BTB 00179-00238 REV1 (1410)

Noncompliance Recall: TLX Certification Label

Supersedes 14-036, dated September 27, 2014, to revise the information highlighted in **yellow**.

TWO DIFFERENT CORRECTION STICKERS WITH TWO DIFFERENT DATES

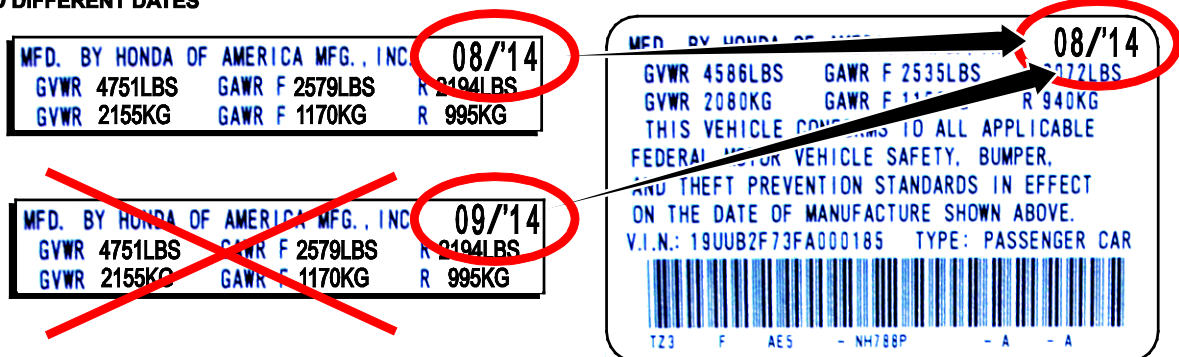
- Select the proper correction sticker option because there are two correction sticker options involved in this recall. One has a manufacturing date of 8/14 and the other is 9/14. **You must put the correction sticker with the same production date as the certification label.**

Match the production dates.
